MEETING AGENDA OF THE CLEARFIELD CITY PLANNING COMMISSION

1. Discussion and Possible Action on **SP 2019-110019**, a site plan proposal by Davis County for a 13,890 square foot library at the subject property. **Location:** 1 North Main Street (TIN: 12-930-0003). Parcel Area: 1.5 Acres. Zone: CV (Civic). **Planner:** Brad McIlrath (**Administrative Action**).

SUBJECT: Discussion and Possible Action on **SP 2019-110019**, a site plan proposal by Davis County for a 13,890 square foot library at the subject property. **Location:** 1 North Main Street (TIN: 12-930-0003). Parcel Area: 1.5 Acres. Zone: CV (Civic). **Planner:** Brad McIlrath (**Administrative Action**).

Attn: Brad McIlrath, Senior Planner
Proj: **Davis County North Branch Library**
Subj: Review #1

CS100

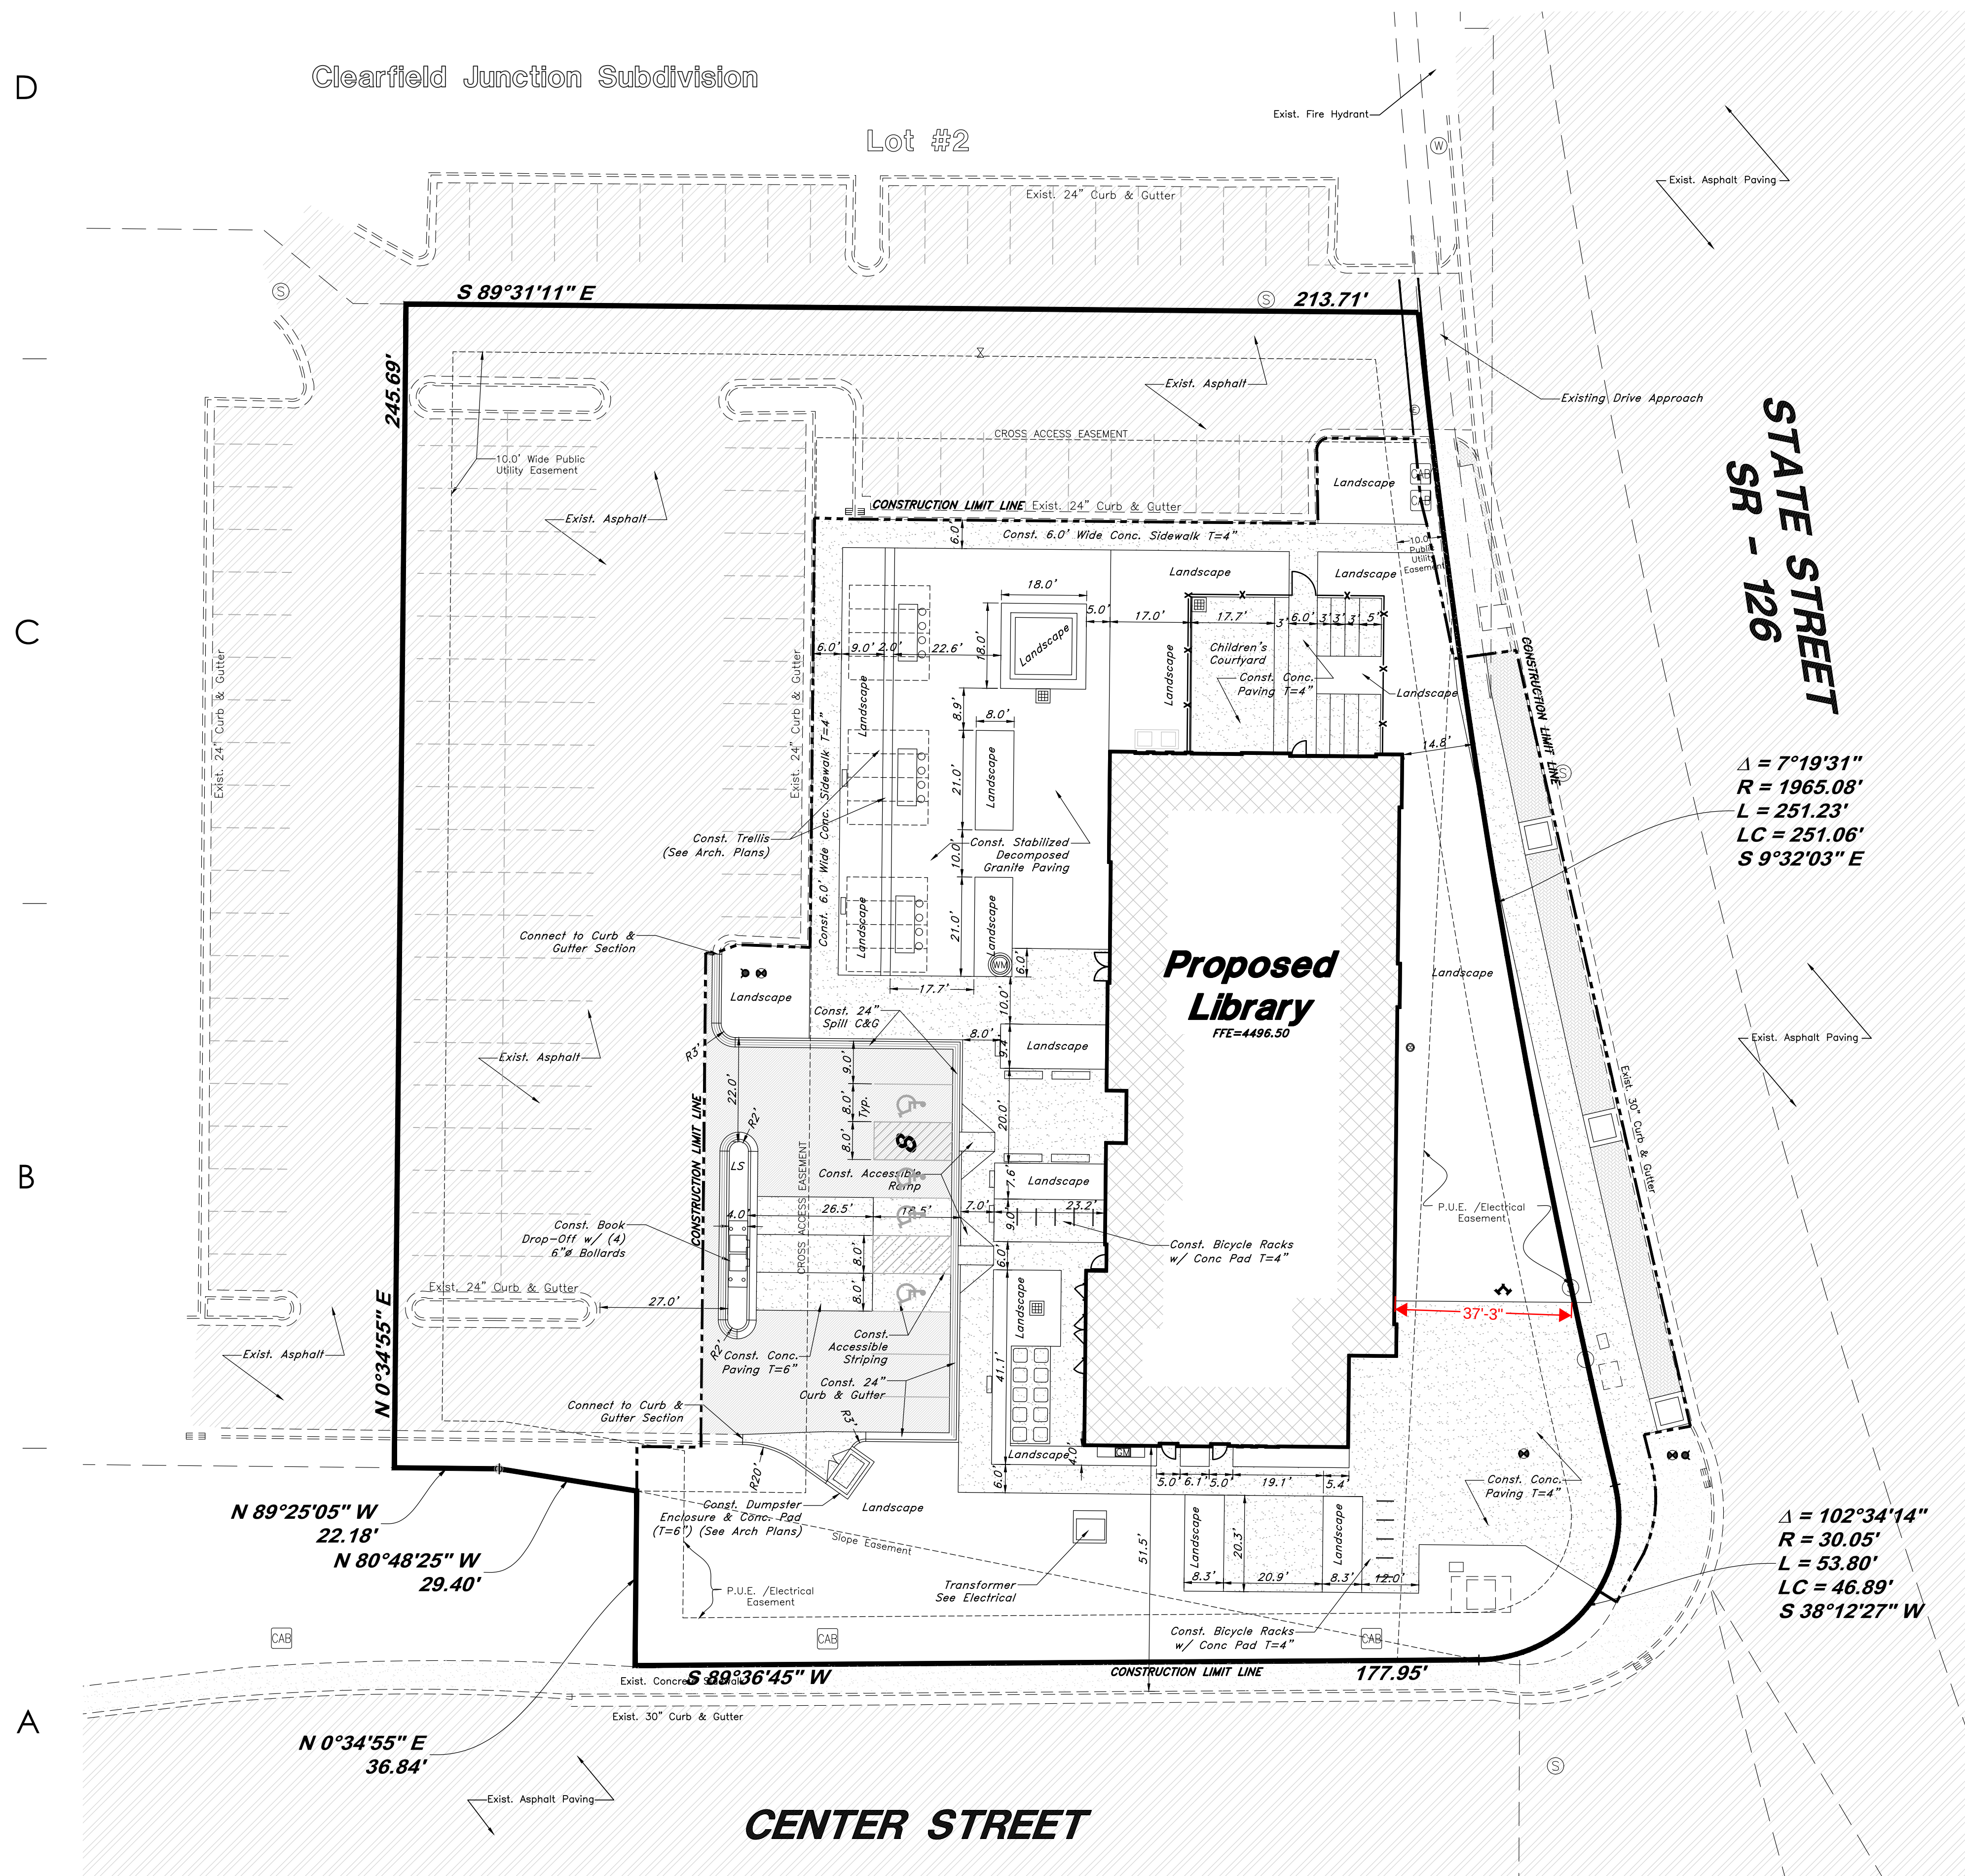
As outlined in Clearfield City Code Section 11-13-5 G "Snow Stacking Area", "Every parking lot design shall plan for a snow stacking area to accommodate the stacking volume of a four inch (4") snow base over the entire parking lot." The current plans do not indicate a snow stacking area and will need to be revised to show the area(s) that a truck would reasonably place snow during the winter.

- 4) The public sidewalk shall be constructed with the concrete and paver materials to match the pattern required by the FBC.
- 5) The plans shall be revised to provide a snow stacking area that meets the standards outlined in Section 11-13-5 G of the Clearfield Municipal Code.
